# **Cleveland City Planning Commission**

July 18, 2025

## **AGENDA**

**CSE2025-026** – 6806 Harvard, Car Sales Lot w/ Office

**SD.33**

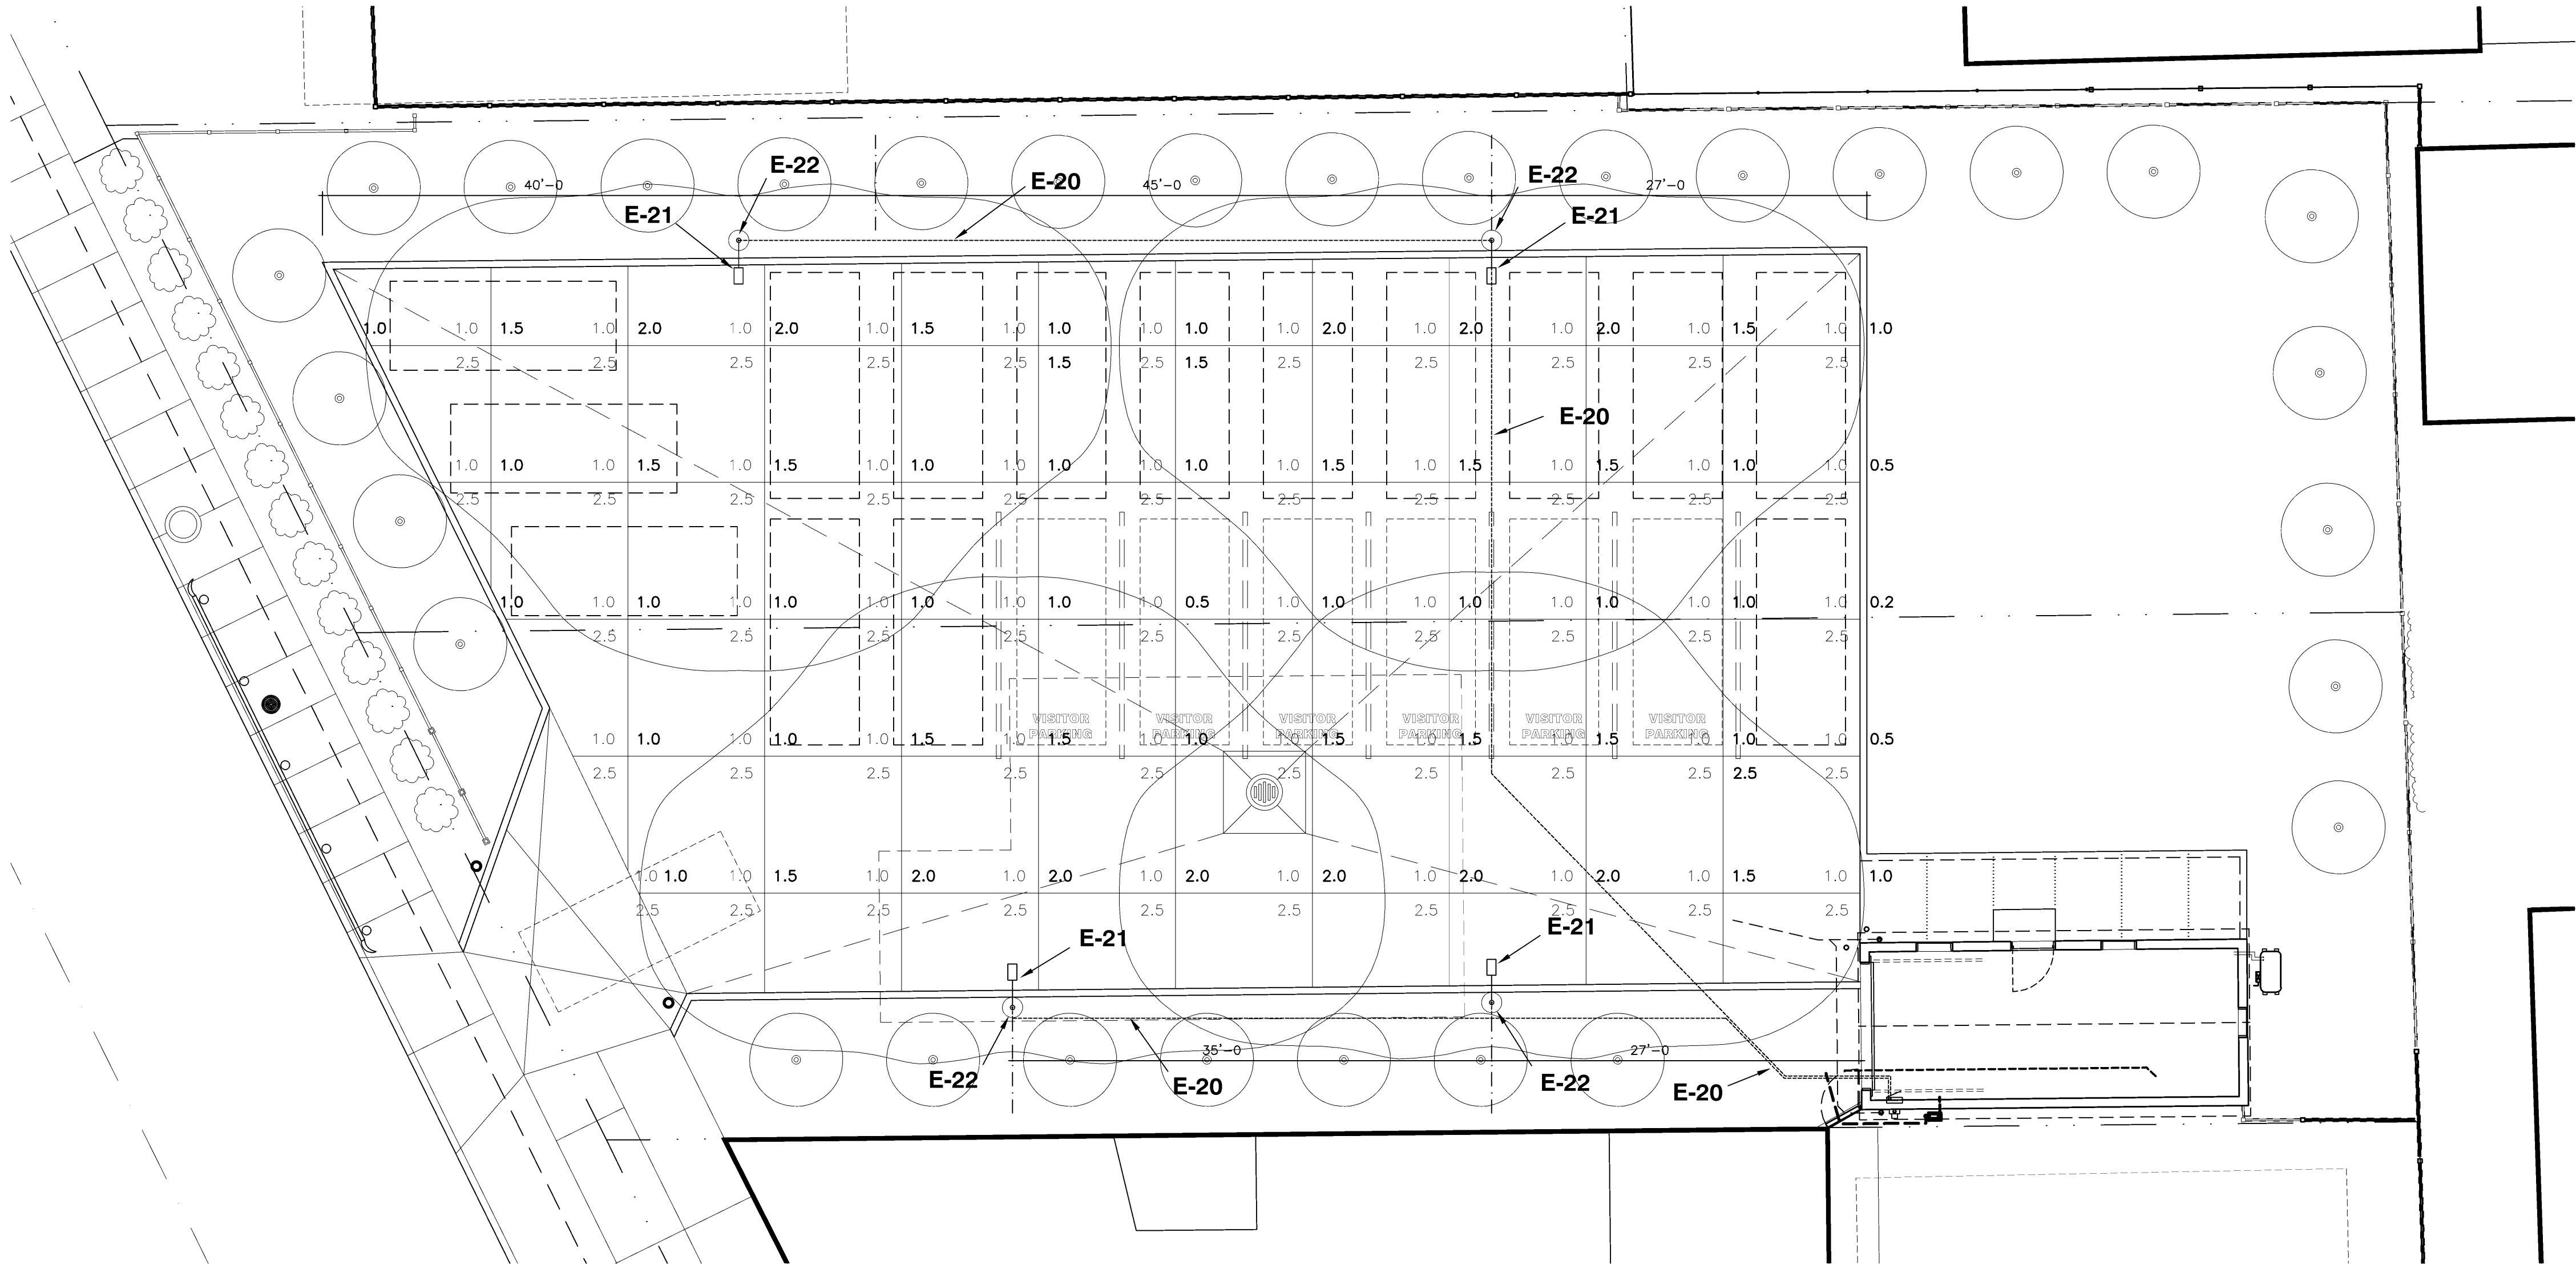
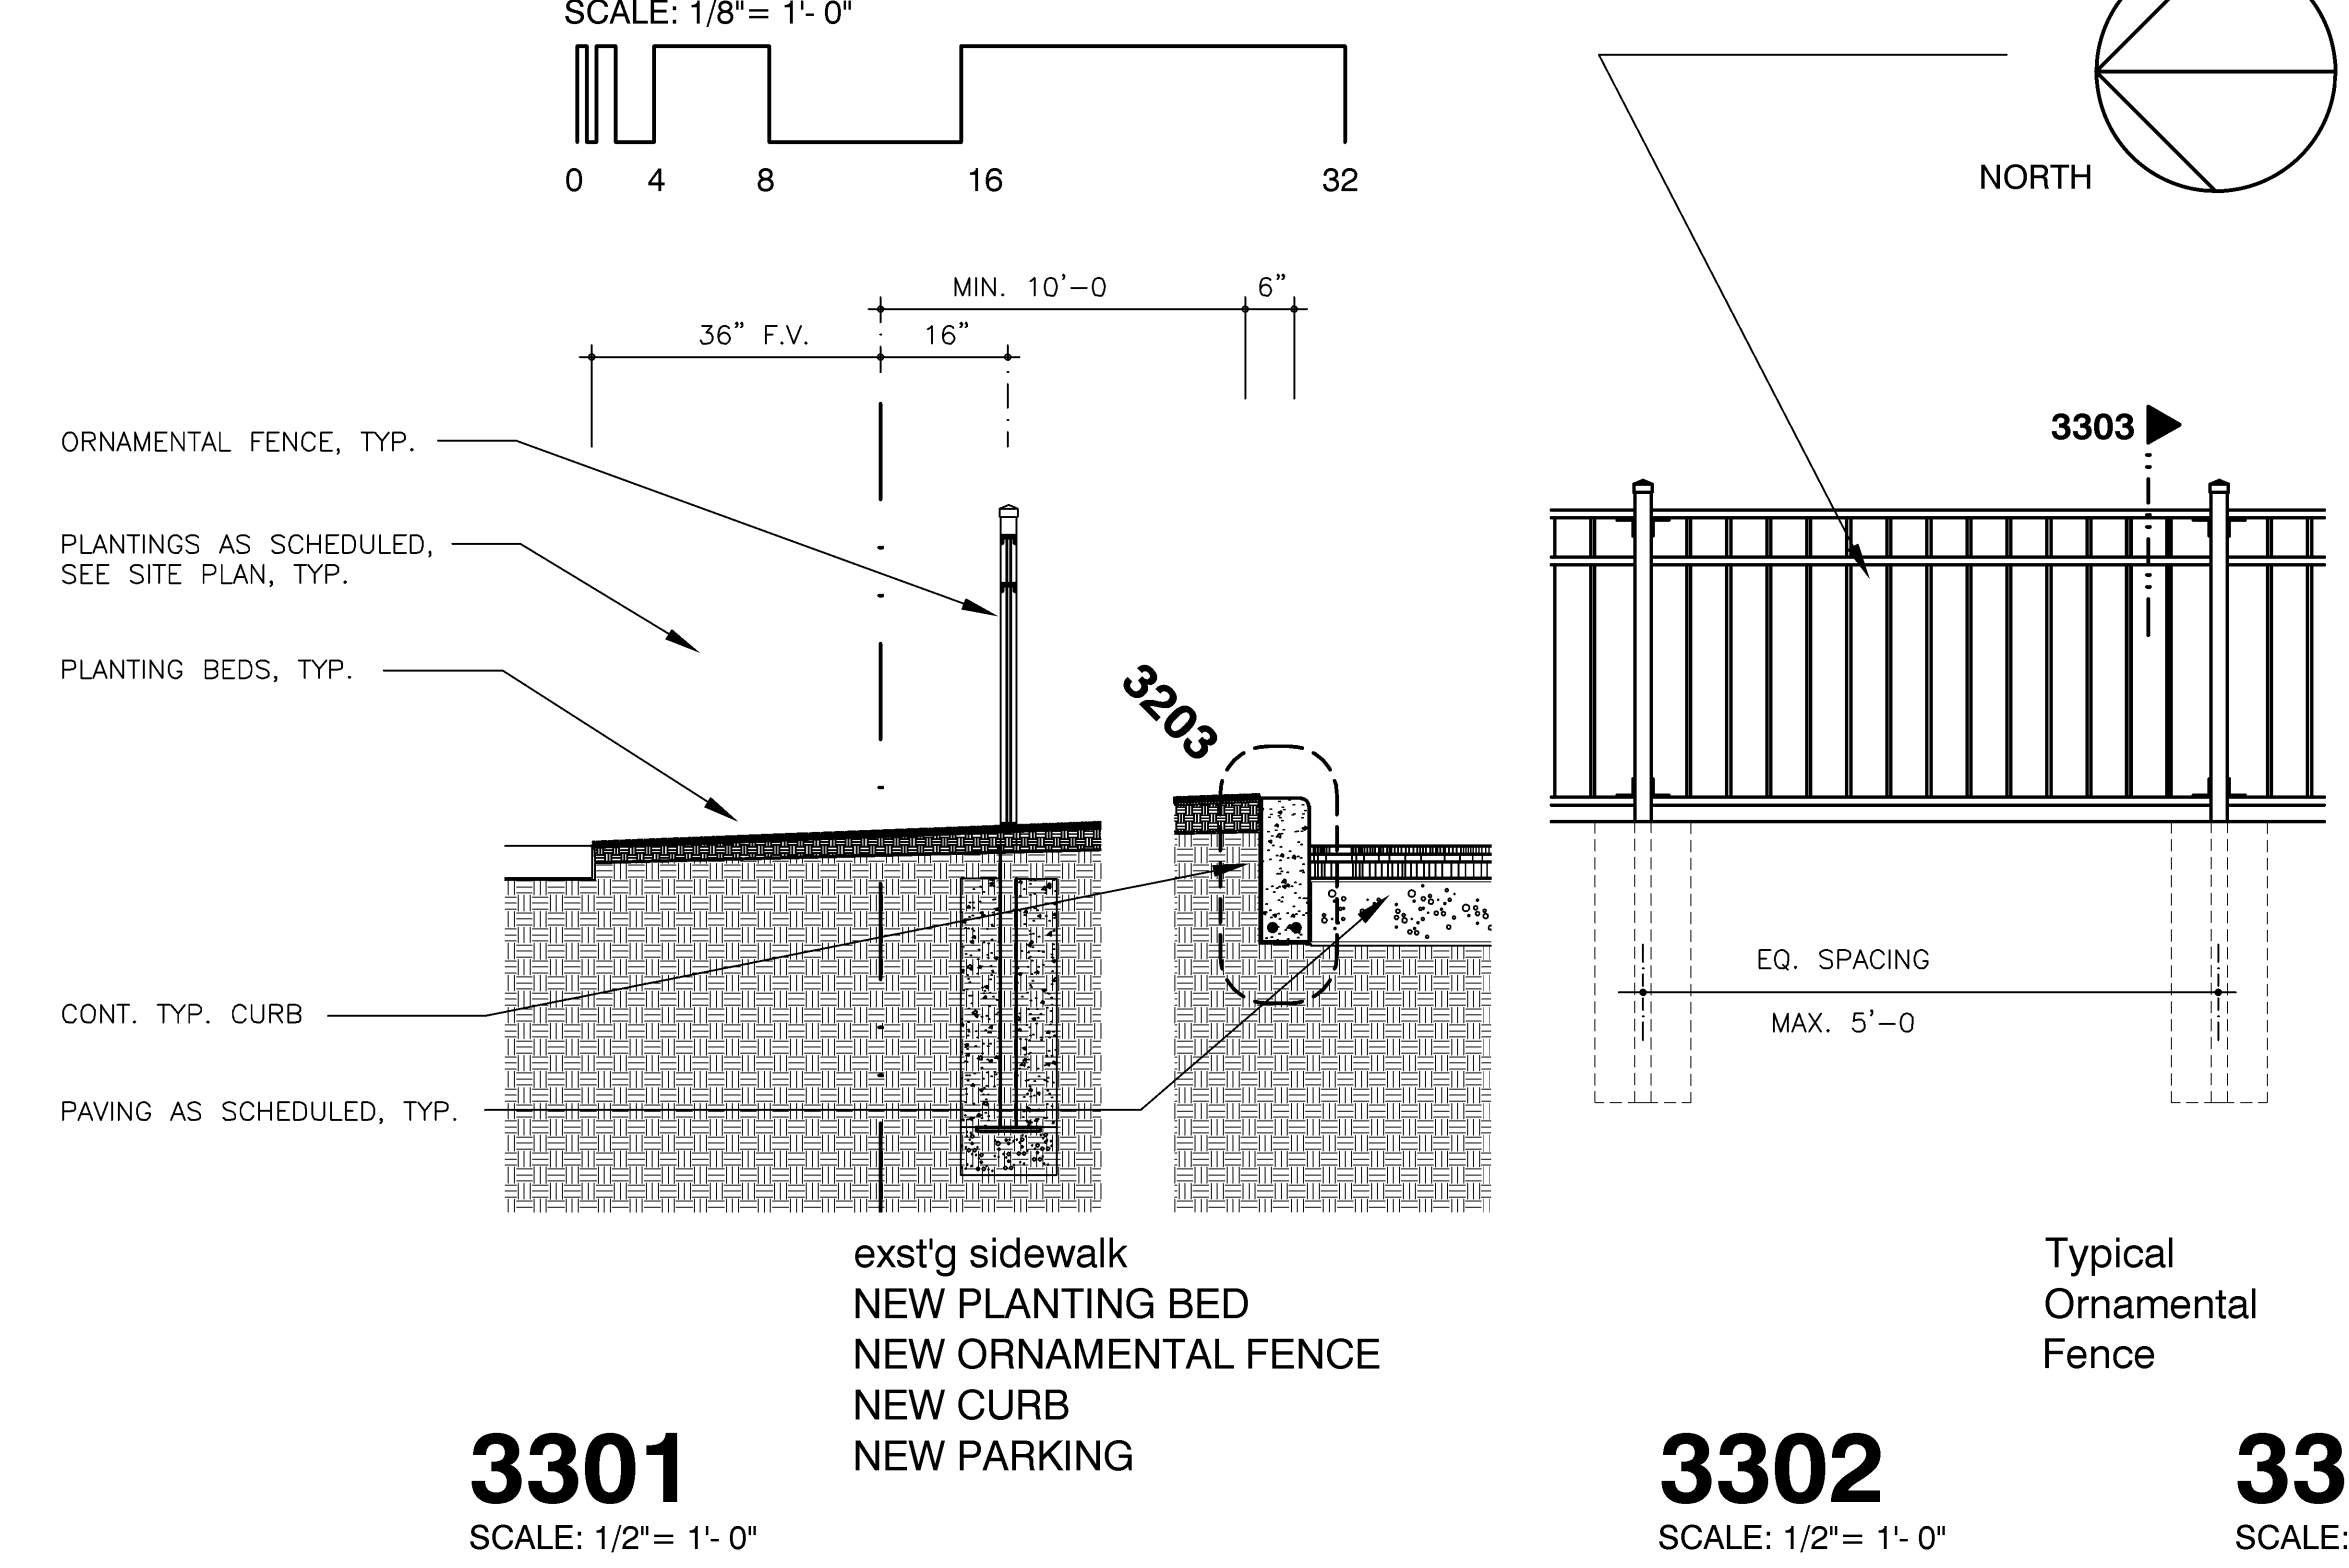
1. ADD additional TREES (3) additional sides (north, east & west)
2. Plantings along Harvard to be EVERGREEN
3. ALL added trees to be HONEY LOCUST
4. ADD (2) additional trees along south side where previously existing concrete pad is no longer present.
5. Requested that owner ROTATE INVENTORY
6. Site Lighting calculations.
7. Details of Ornamental and Board on Board Fencing.
8. "Vistor Parking" text added to visitor parking spaces.
9. Remove entry curb encroachment on west set back line.
10. Building Exterior Finishes.

Items 1, 2, 3, 4, 8, and 9, are addressed on revised site plan drawing SD.33.

1 SITE PLAN  
SCALE: 1" = 30'

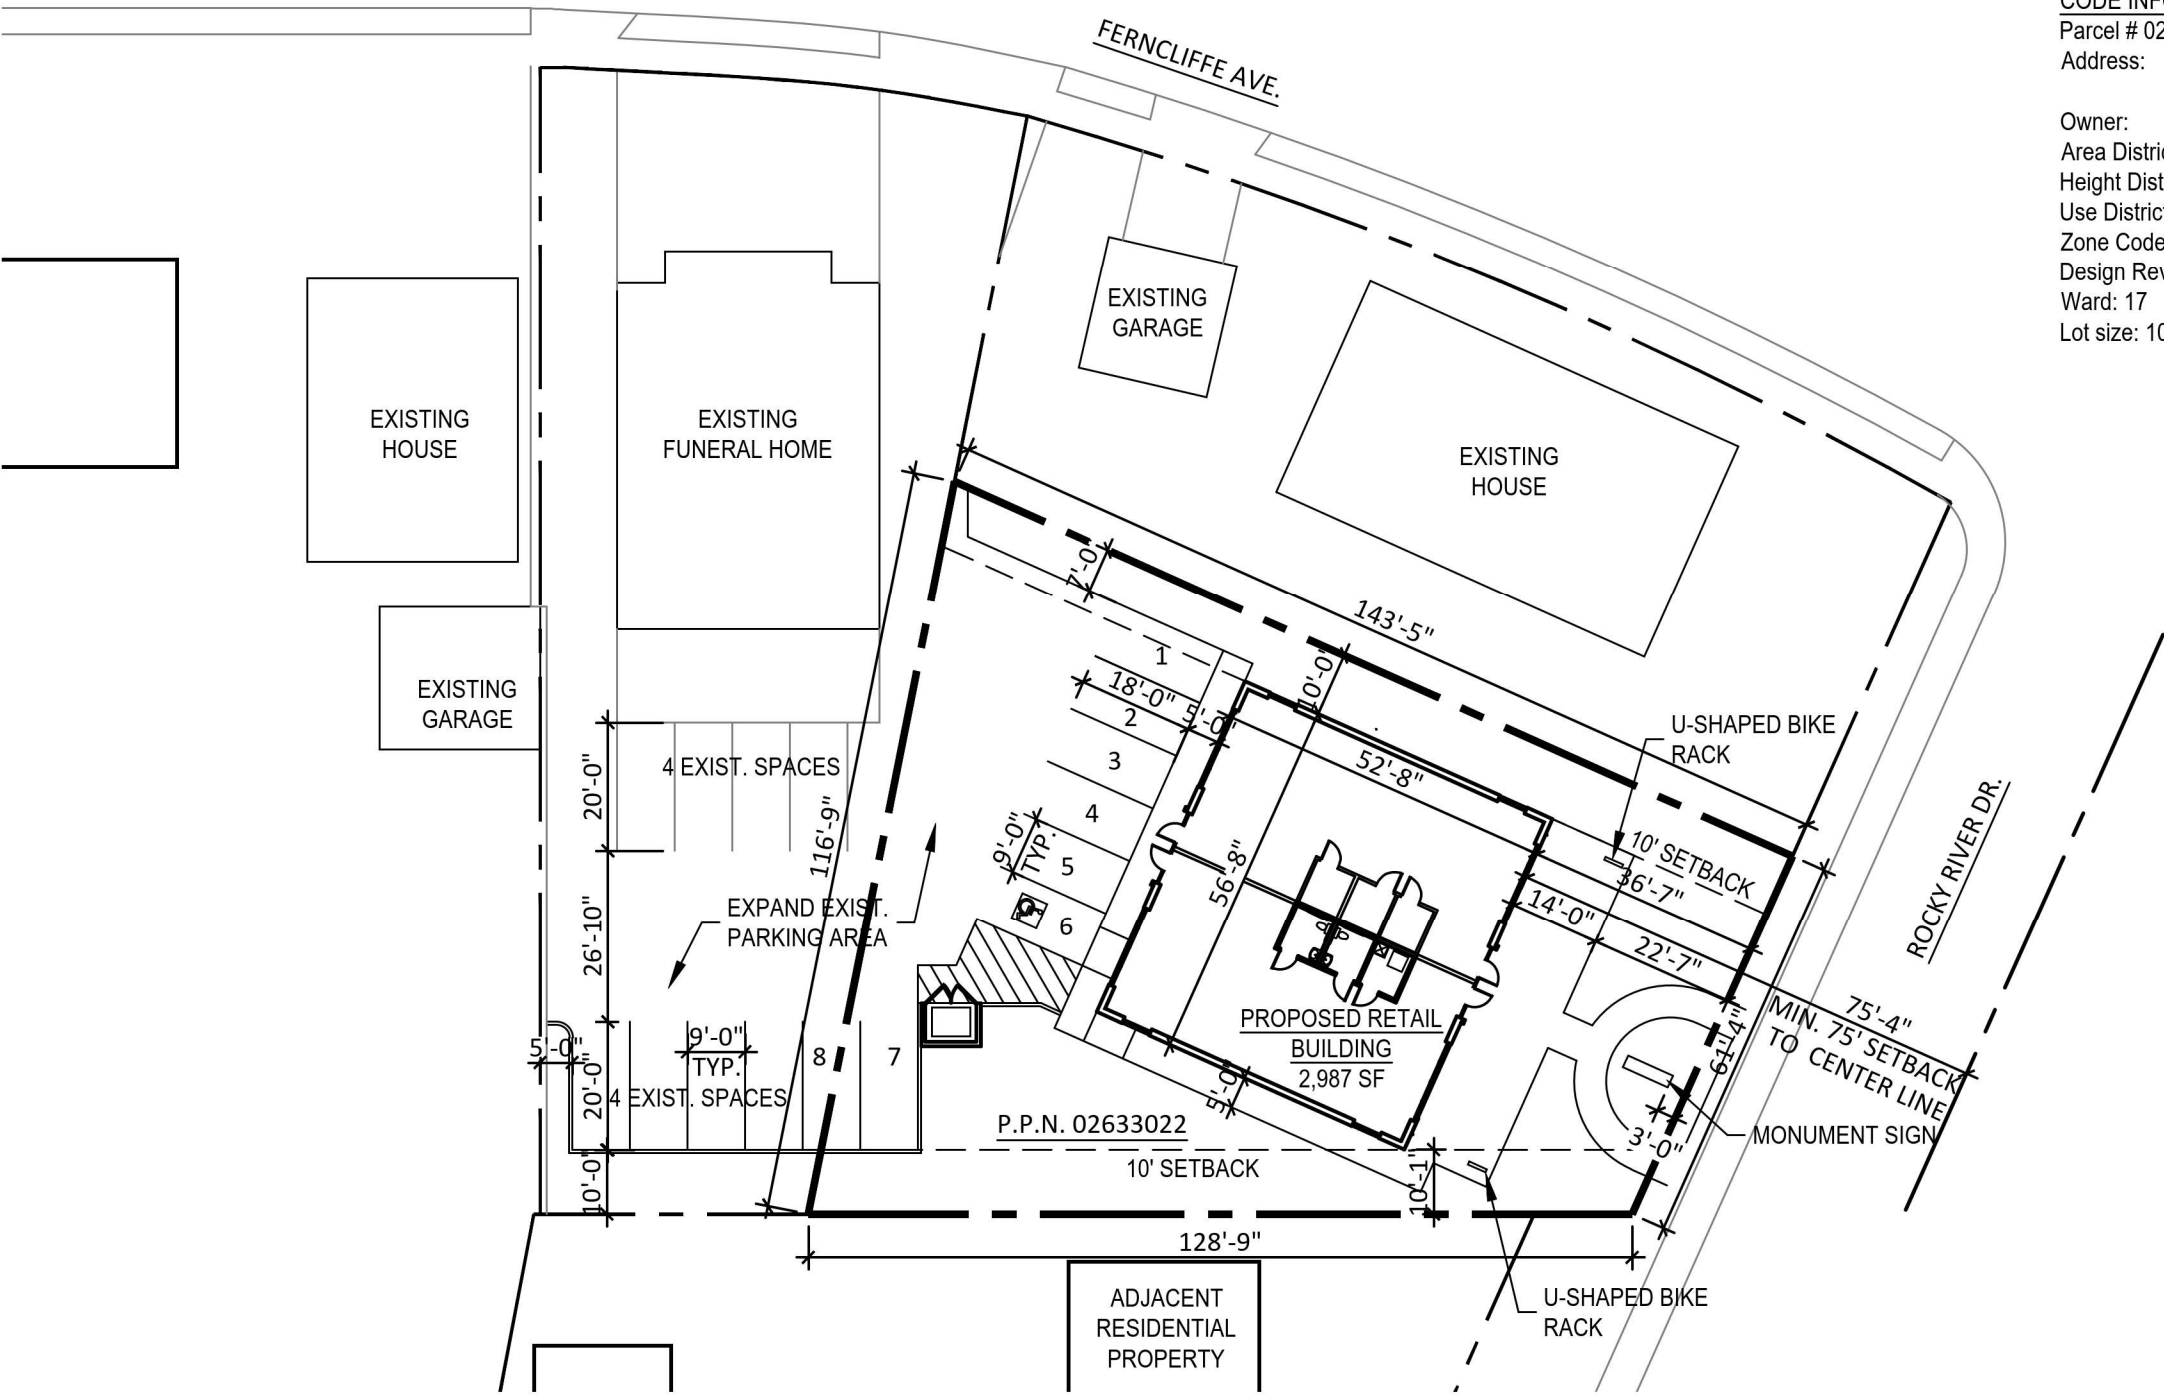
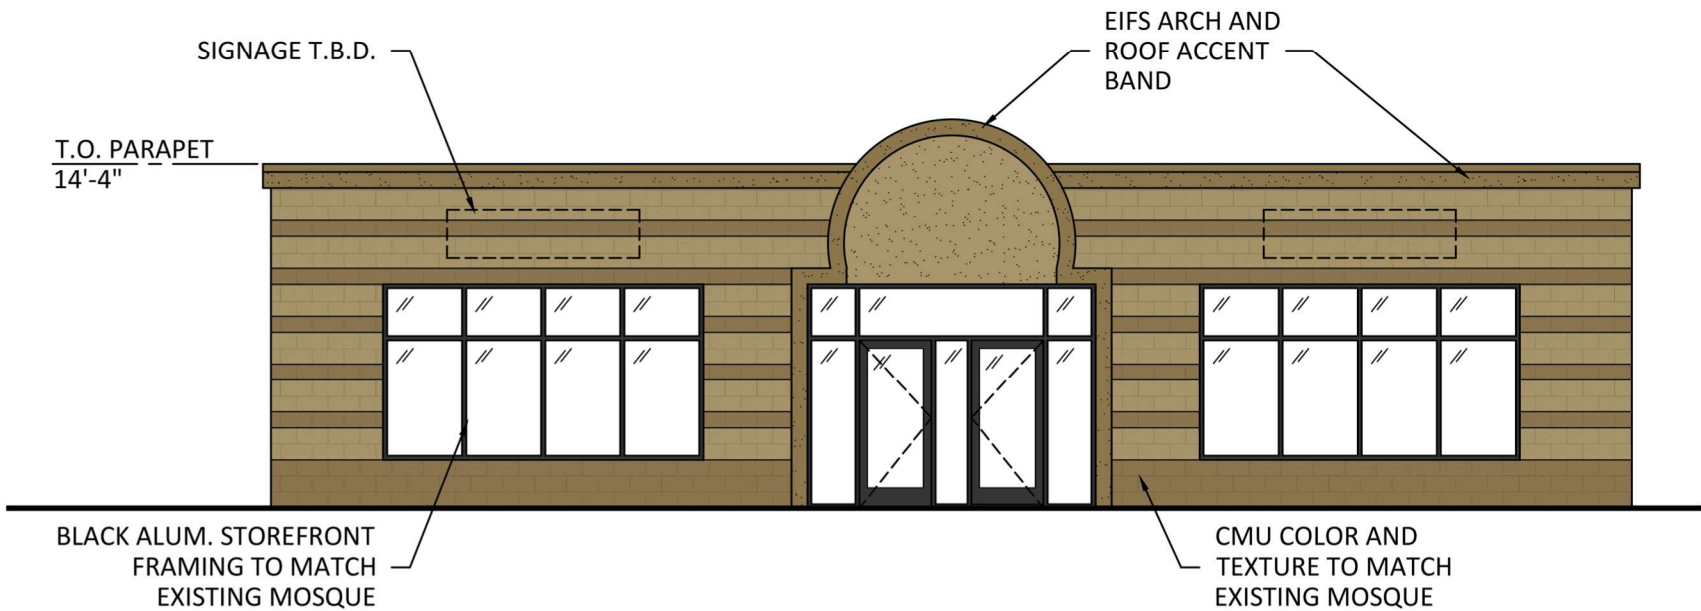
- Remove as much impervious surface as possible to soften site
  - Landscaping plan with emphasis for screening adjacent residential needed at schematic
  - Full photometric plan needed for parking lot and building
  - Strong consideration should be given to flipping or matching east/west elevations to increase storefront glazing
-
